| APPLICATION NO. | FILING DATE | FIRST NAMED INVENTOR | ATTORNEY DOCKET NO. | CONFIRMATION NO. |
|-----------------|-------------|----------------------|---------------------|------------------|
| 10/014,868 | 12/14/2001 | Shih-Ming Huang | 3126-222 | 1779 |

| Office Action Summary | Application No. 10/014,868 | Applicant(s) HUANG, SHIH-MING | |

DETAILED ACTION

FIG. 1
PRIOR ART

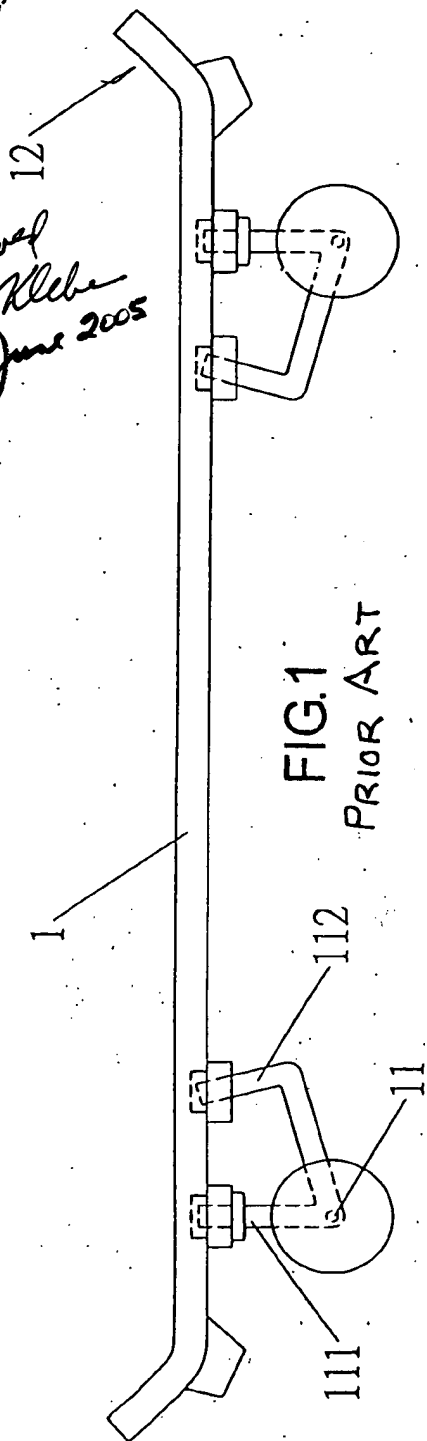
2. The proposed drawing change to Figure 1, filed 11/29/2004 is approved by the examiner.

*Approval
4/1 Klebe
28 June 2005*
